**FIRE STATION NO. 4 2ND STORY ROOF REPLACEMENT
CIP 2026-32**

ADDENDUM NO. 2

This Addendum No. 2 (11 pages in total) forms an essential part of the contract documents by revising the following:

Figure 1: Roof Mounted Antennas to be Removed

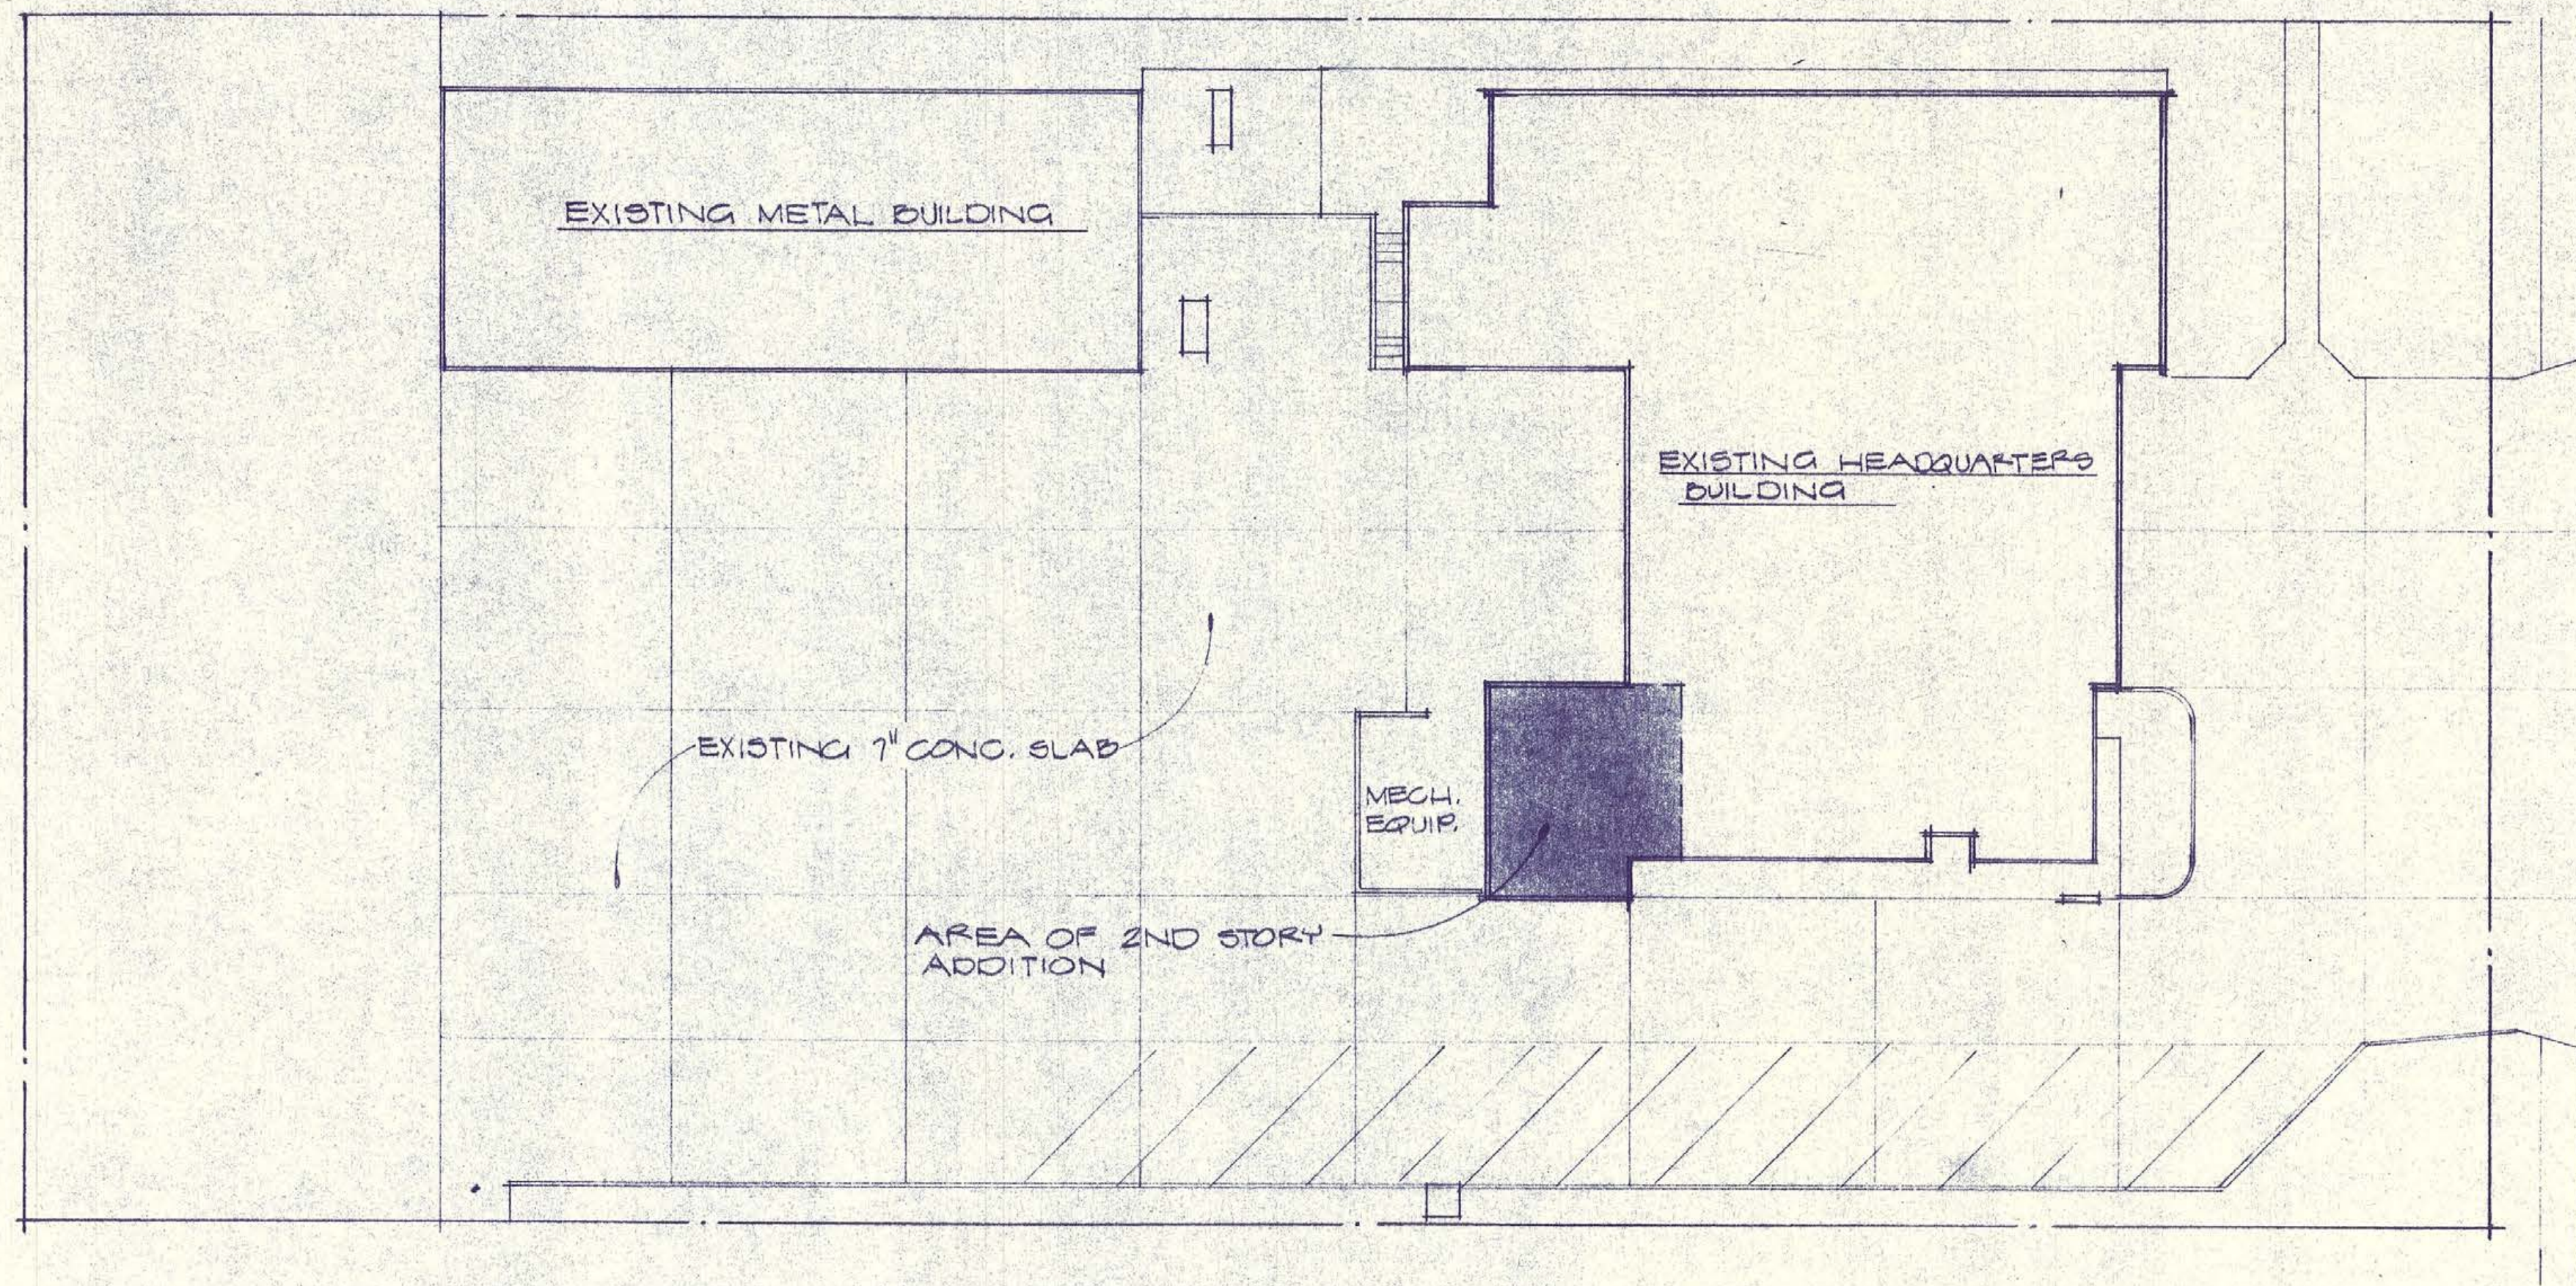
2D-1 Question: Do the antennas mounted to the roof need to be protected in place, or can they be removed?

Response: The two antennas positioned on the North side of the roof can be removed. The single antenna that is mounted to the clerestory vault at the center of the roof is still in service and will need to be protected in place during construction. The Contractor shall be responsible for removing the antennas and disposing of its parts and materials. The electrical wires shall be properly terminated and tucked underneath the roof deck to be removed by City staff. The roof penetrations where the antennas were mounted shall be patched and sealed watertight prior to installing the new TPO roof system. Costs associated with the removal of the antennas shall be included in the lump sum bid price for **“Remove Existing Multi-Ply Roof System”**. See Figure 1 below for a photo showing the two antennas to be removed.
